Agenda Item Transmittal

Agenda Title: Discuss and consider action on Site and NPS plans for the Pearl Multifamily development located at 13400 Bee Cave Parkway, Bee Cave, TX including the following plans:

**The Pearl
Bee Cave, Texas**

Re: Morgan (Applicant) Responses to P&Z Question

ELECTRICAL
PHOTOMETRIC
PARKING GARAGE
LEVEL 2

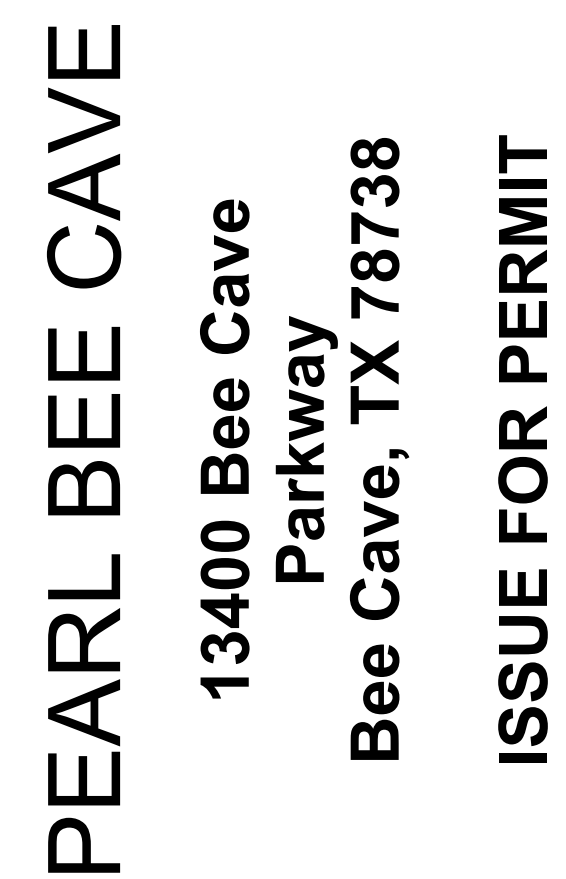
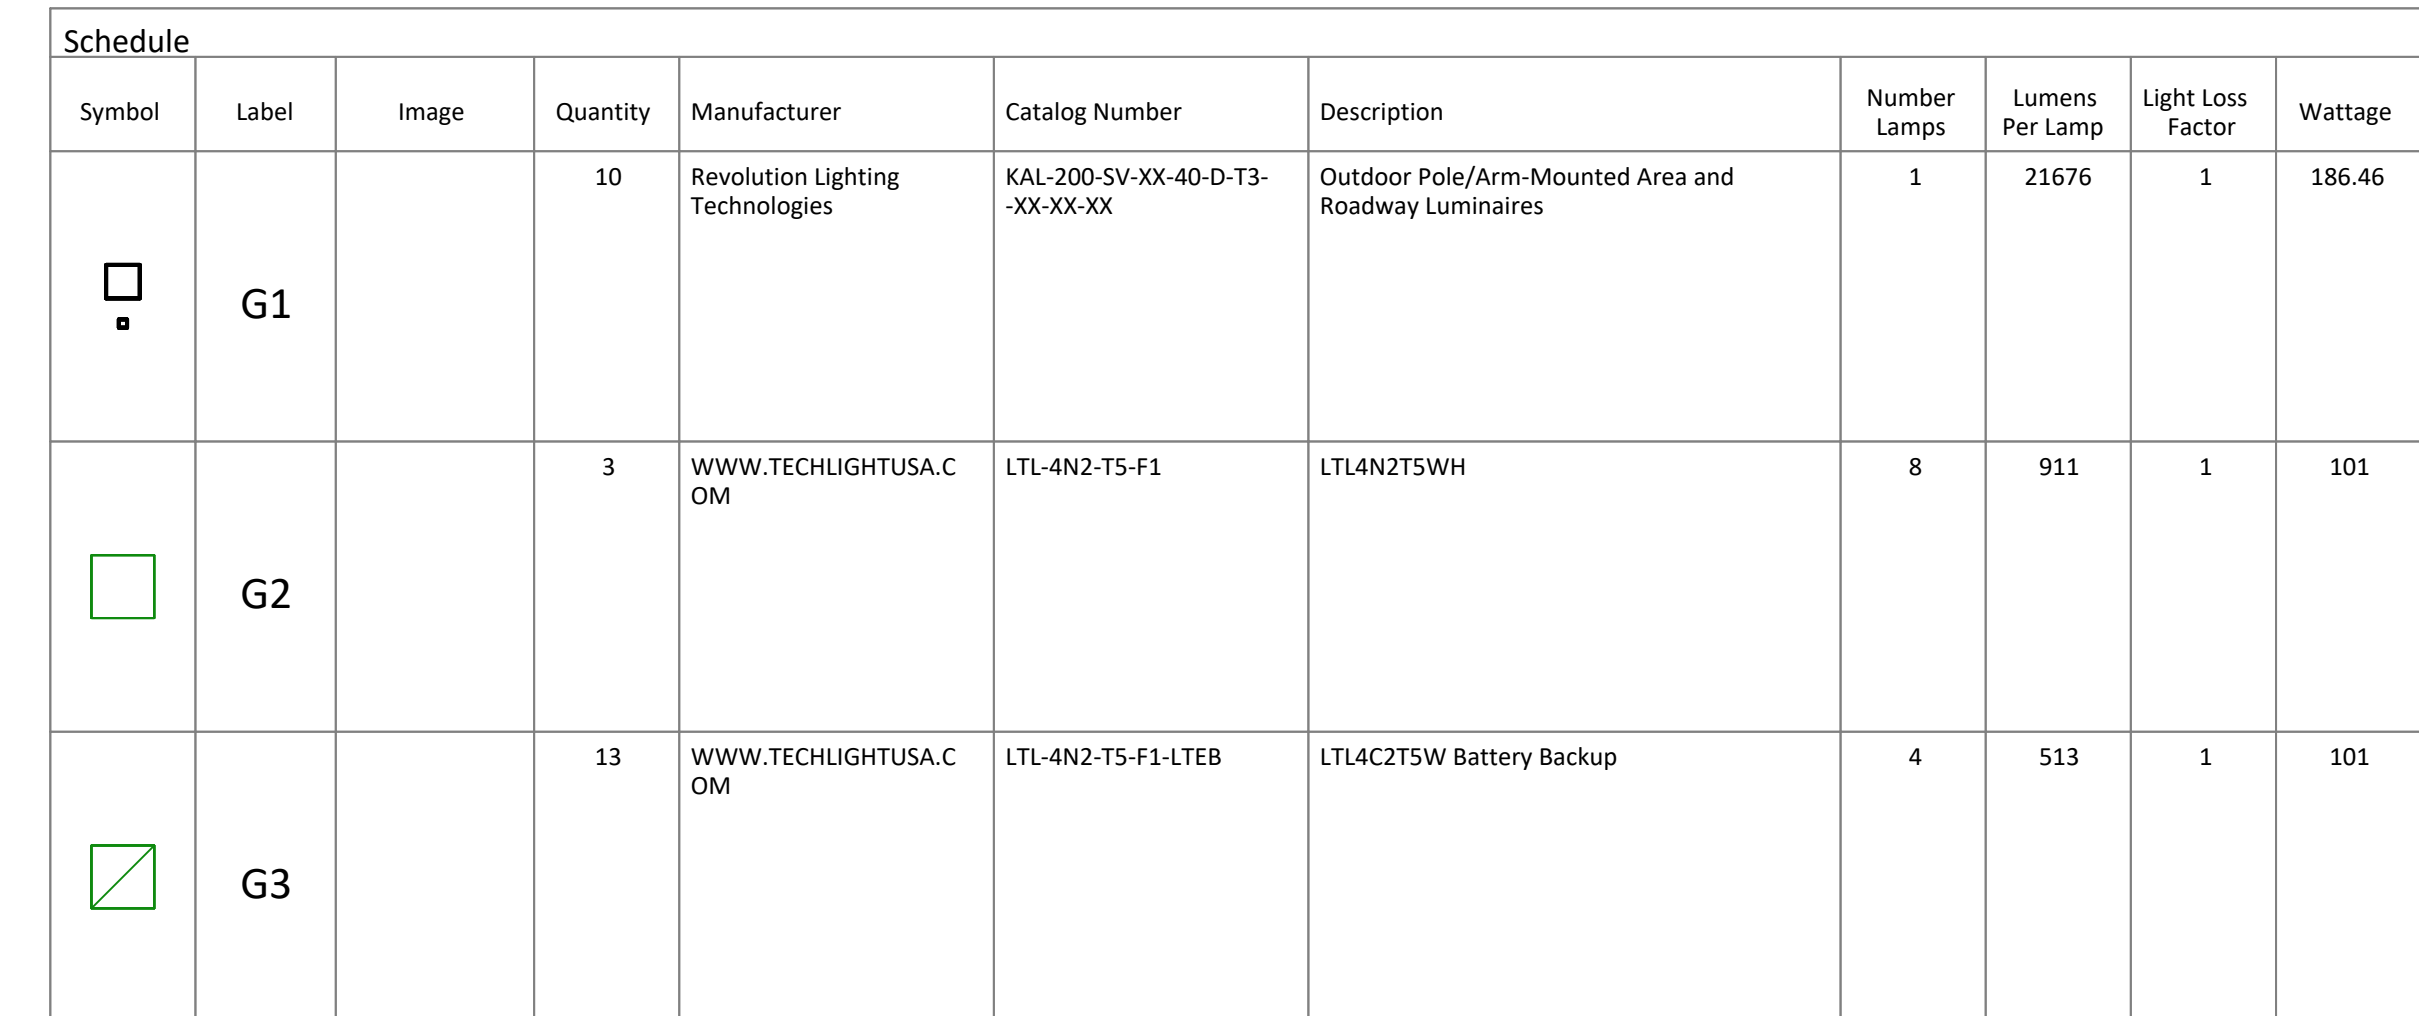
3. Ground Floor Private Yard Compliance with fencing located in the front yard setback. Please see attached consultant report for explanation.
4. Garage architectural elevations are provided in the attached report. The applicant has also provided a photometric study to confirm compliance with Section E Lighting of the PDD as it relates to the parking garage:

IV. Parking Garage Elevations and Photometric Study

The attached photometric plan was reviewed by the City's lighting consultant who confirmed all photometrics provided are in compliance with the requirements of this project. The applicant confirmed there are no plans to mount exterior light fixtures to the buildings.

A photometric study of the garage has been completed and shared with City Staff for review and approval.

LEASING BUILDING - MASSING

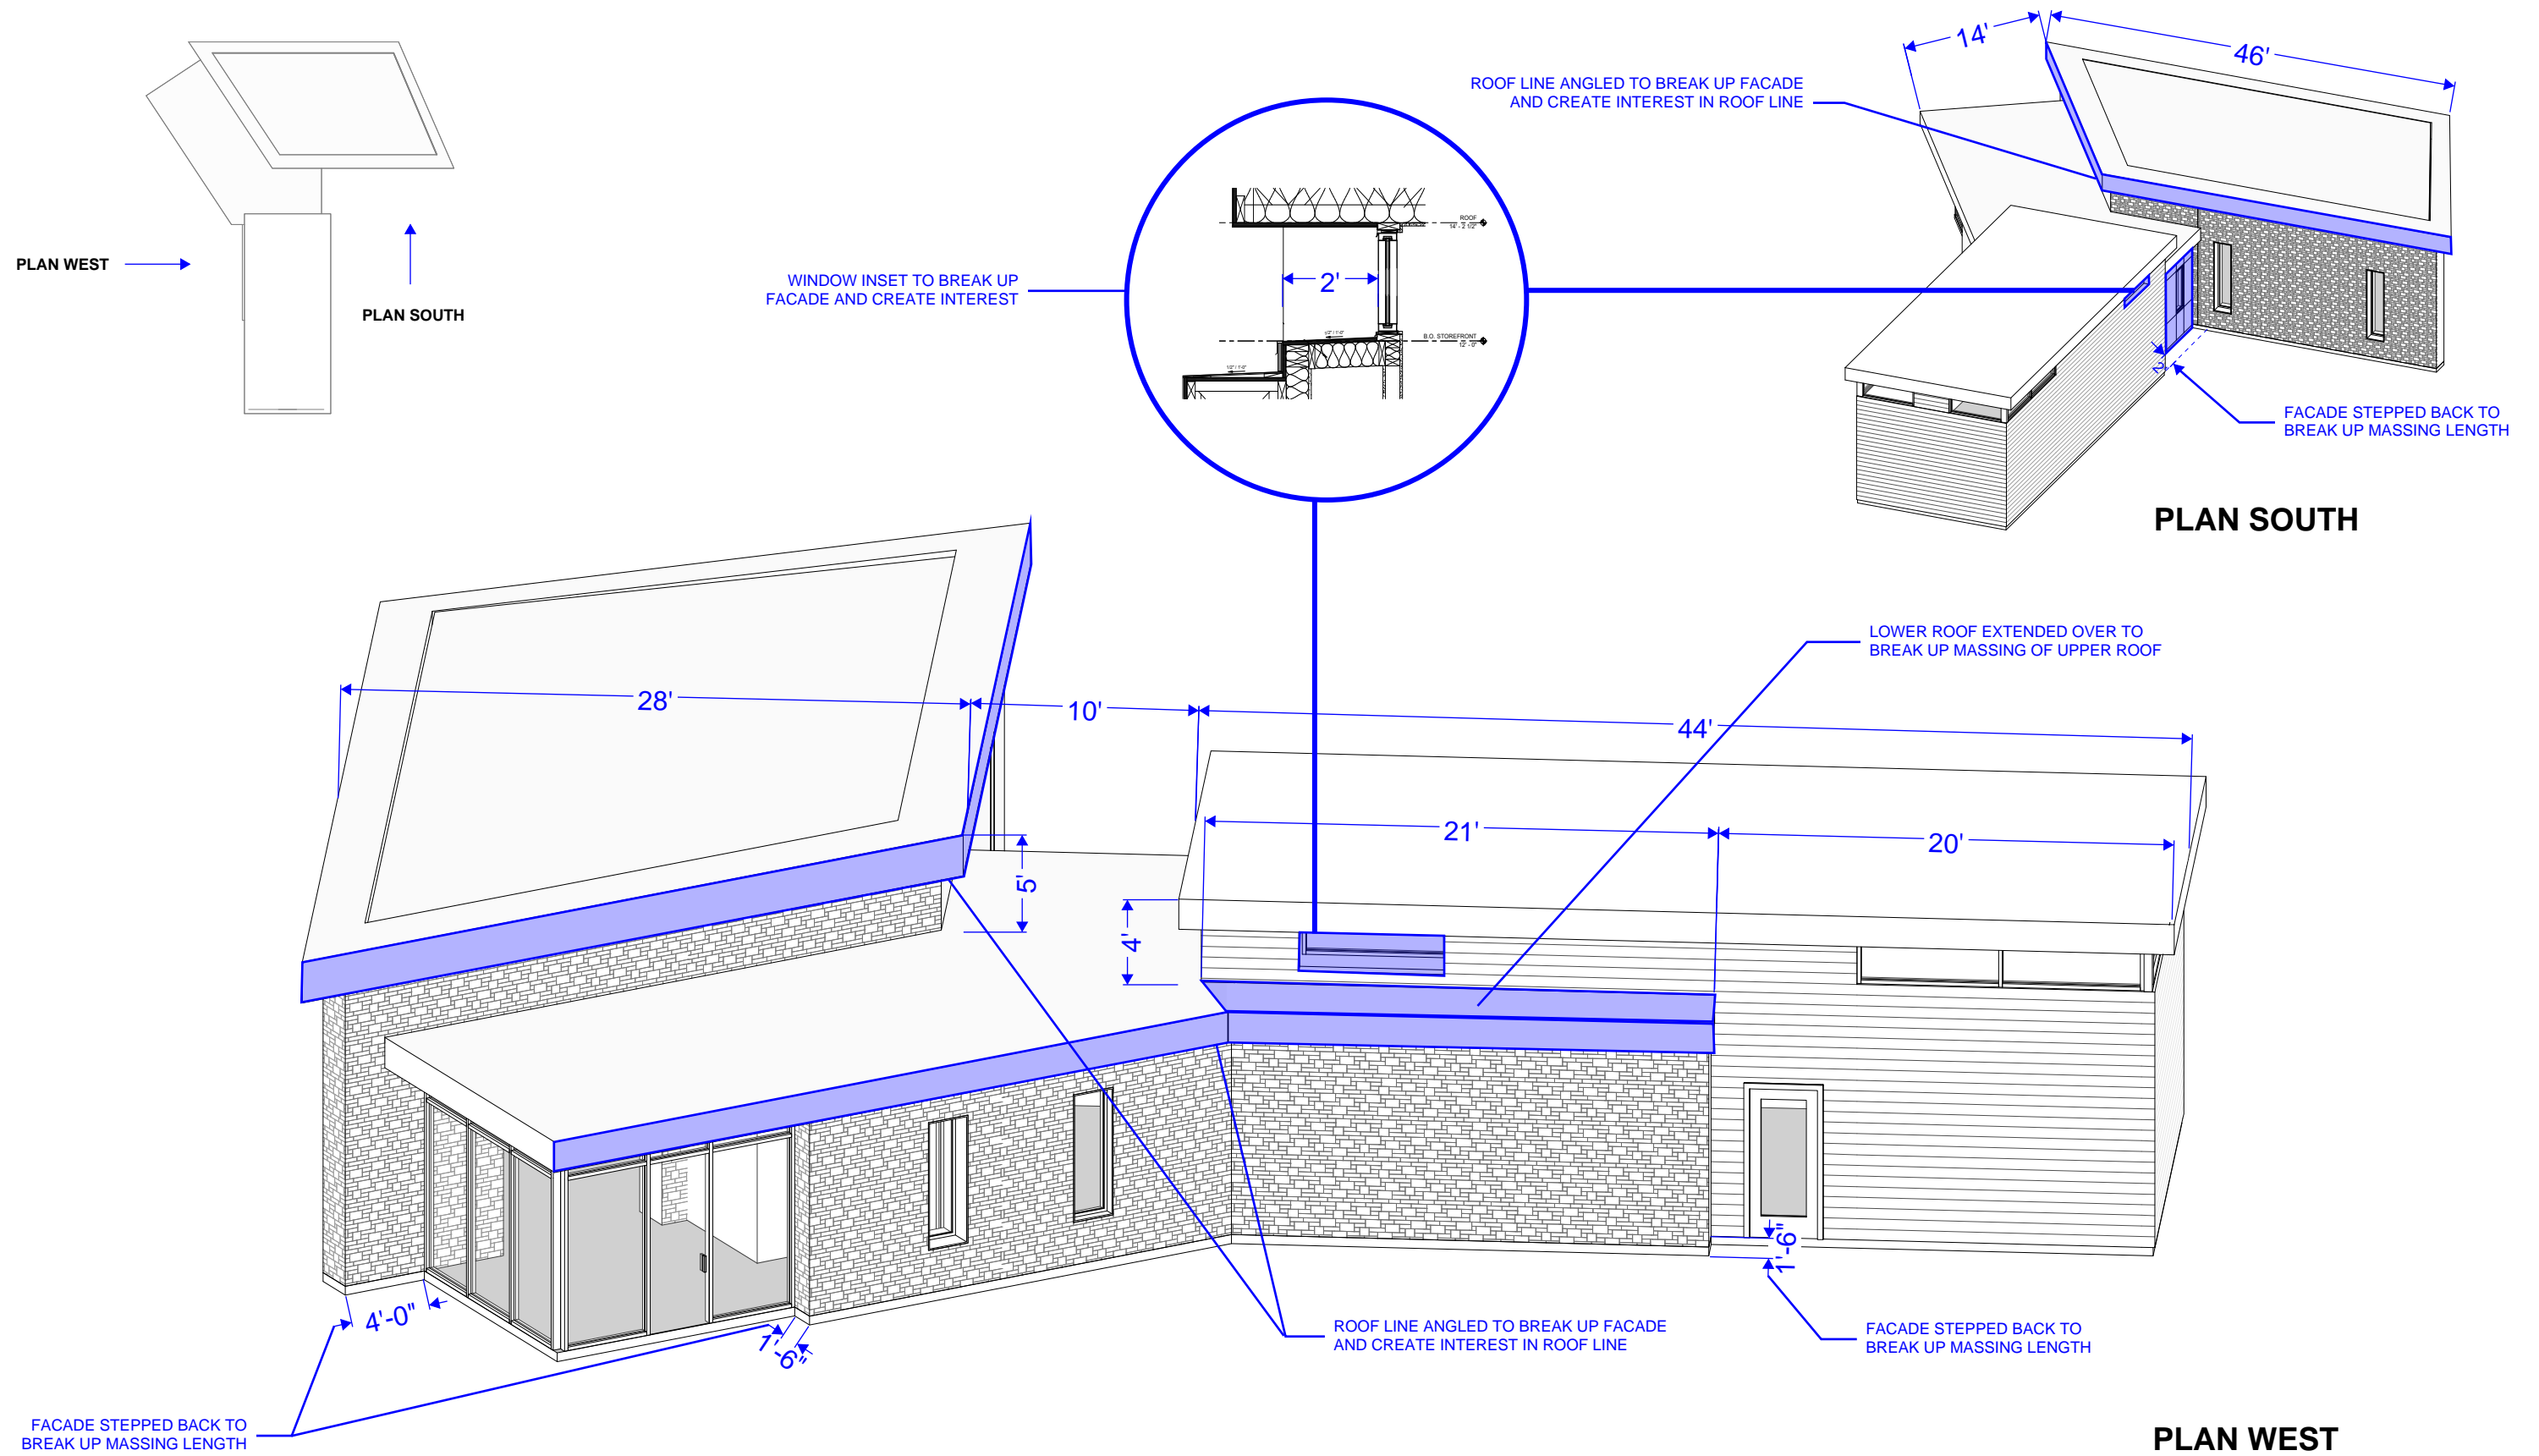
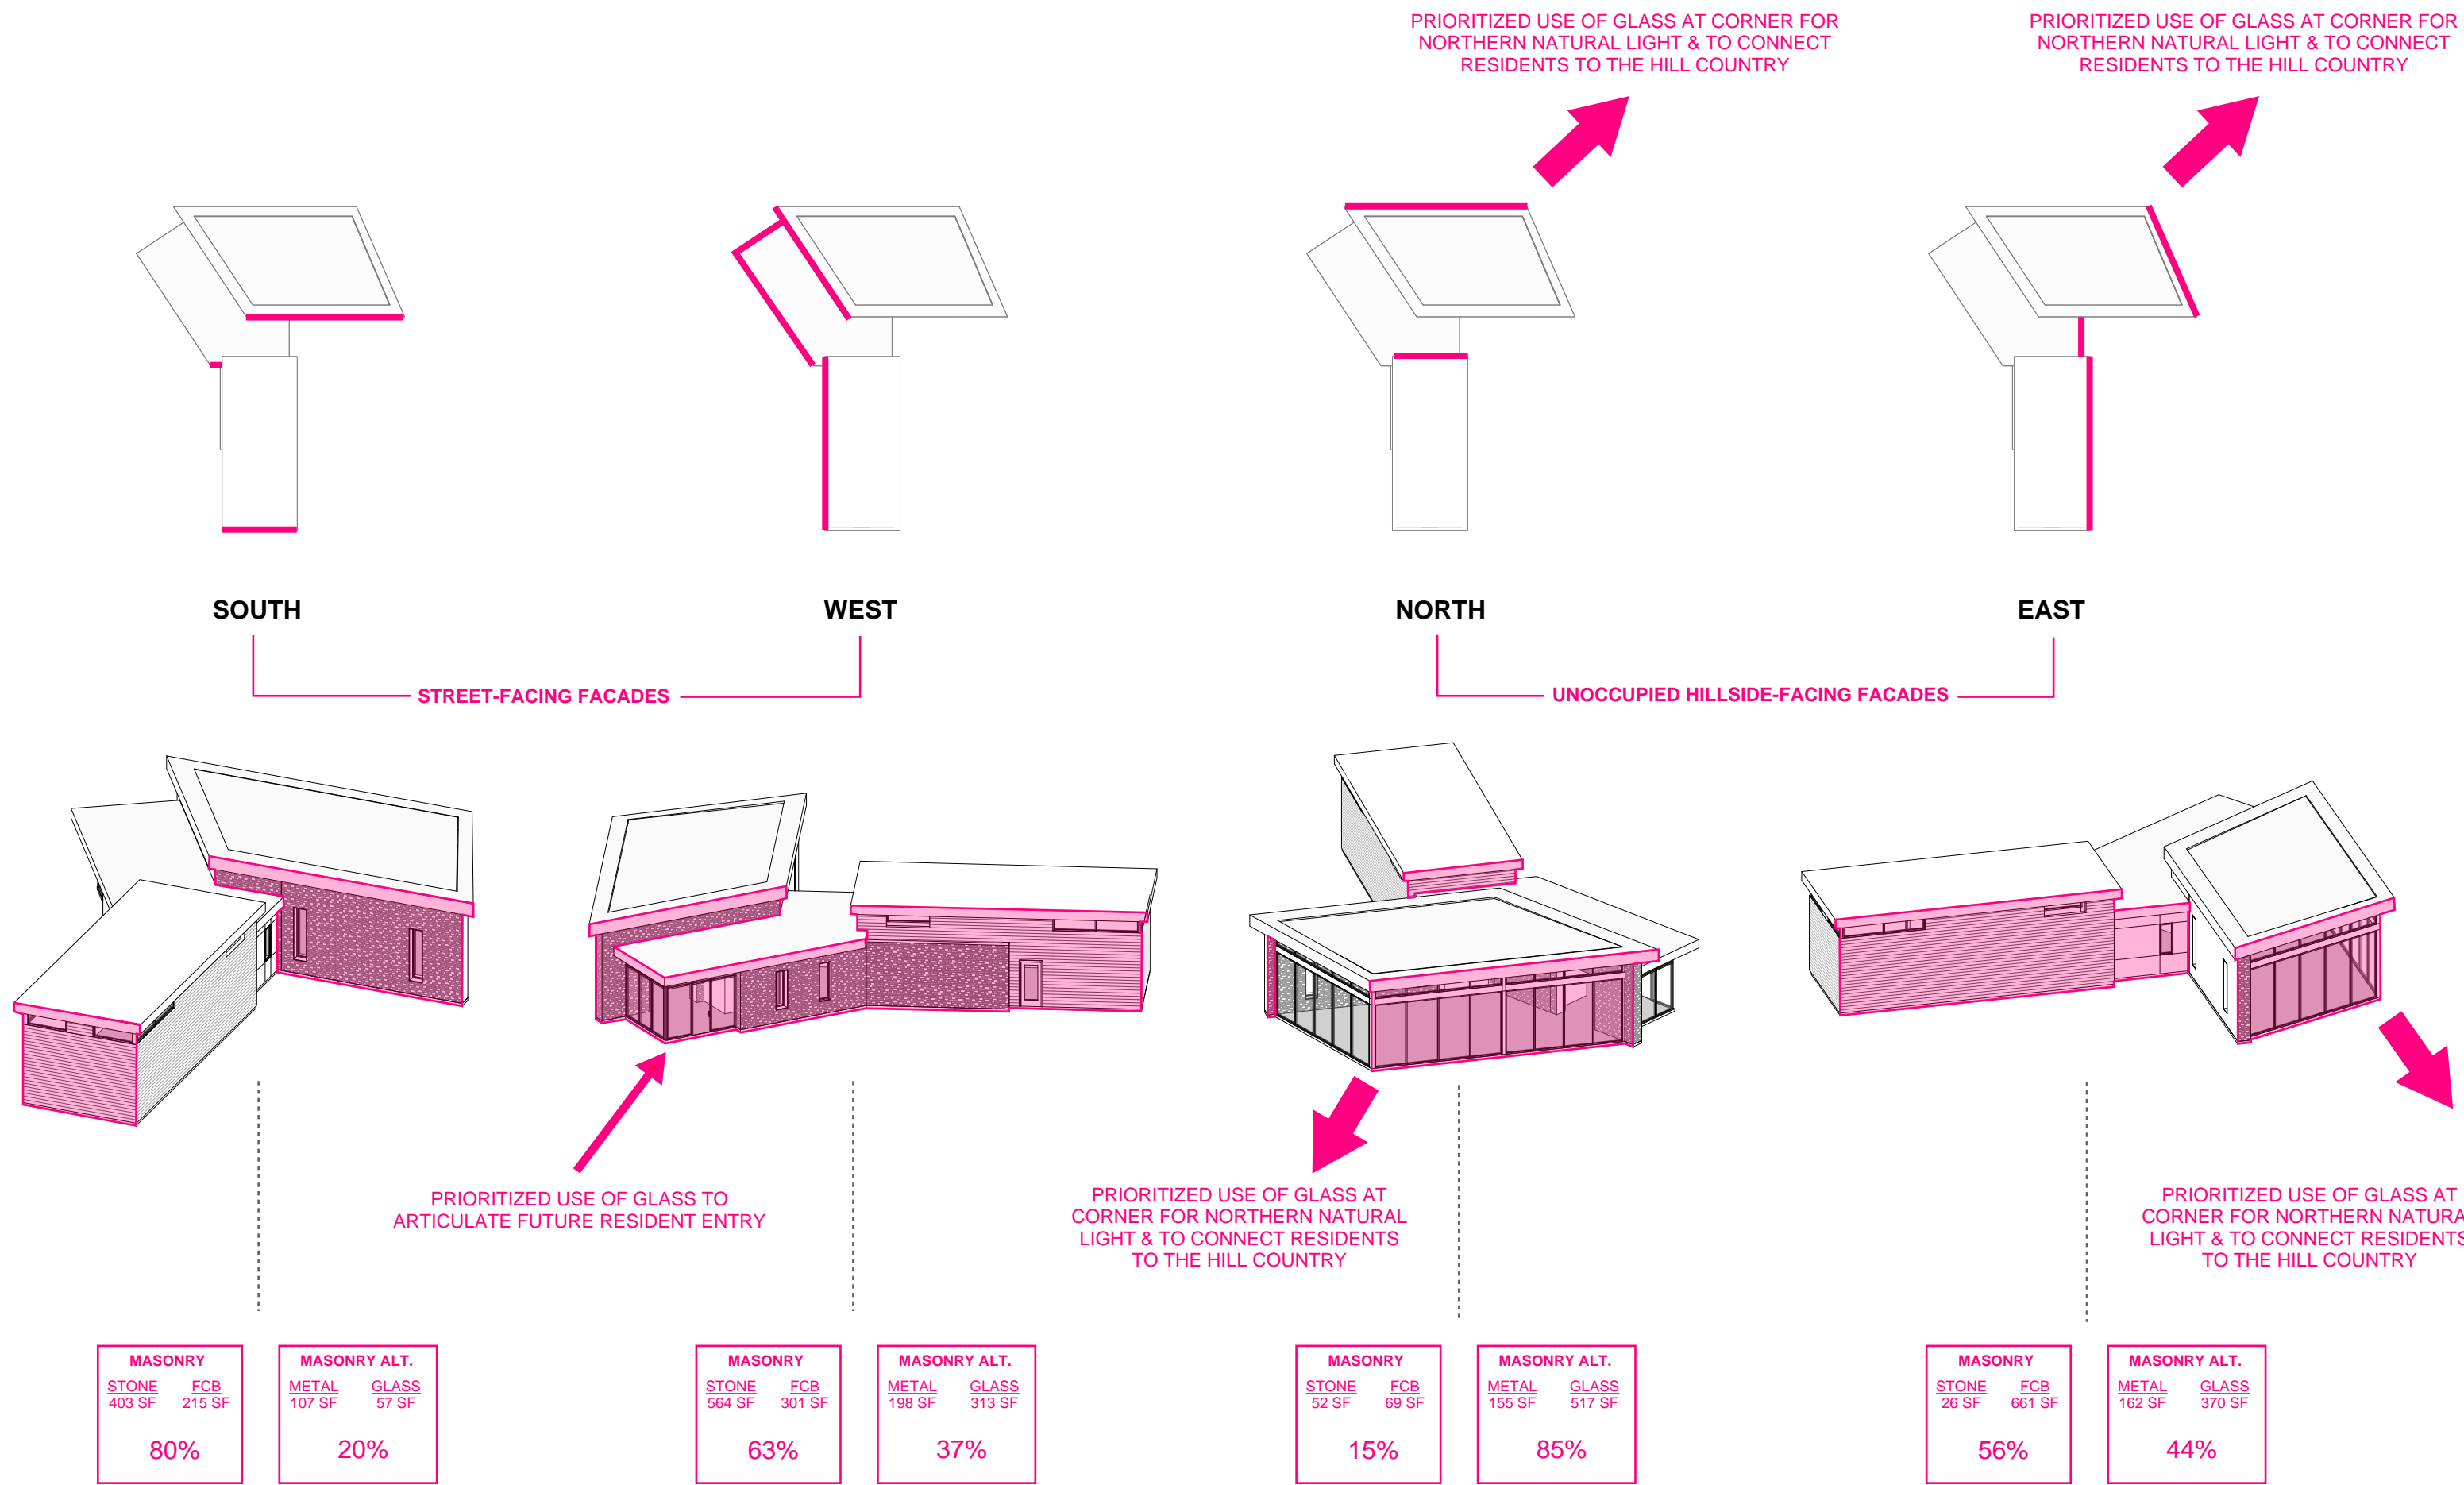
5. Leasing Building - Design Intent Compliance. Please see attached consultant report for explanation.

City Staff and Morgan reviewed the Leasing Office building in great detail to ensure full compliance with the design requirements of the PDD. With three different roof lines and multiple facades and angles along the building, City Staff determined that the building design complied with the the PDD.

The below exhibits detail the various elevations, roof lines, and material percentages of the leasing building facades.
